M-b-332
Supplement 2

November 21, 2006

SUBJECT: Anderson AV 9900 Microprocessor Based Safety Thermal Limit
                Recorder/Safety Flow Limit Recorder (STLR/SFLR) Field Setup
                Guide Revision 3.0.

5.7.1. LED Indicators for "Loss of Signal" and "High Flow" Alarms

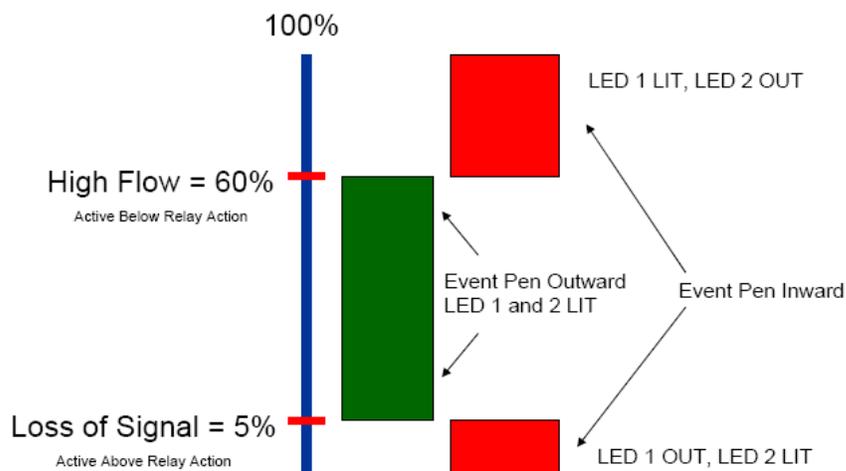
As indicated, the LED's are tied directly to the action of the Loss of Signal and High Flow alarms and relays. The following illustration shows proper operation of the flow alarms:

LED Number 1 – Tied to Loss of Signal (Low Flow) alarm / relay point

LED Number 2 – Tied to High Flow alarm / relay point
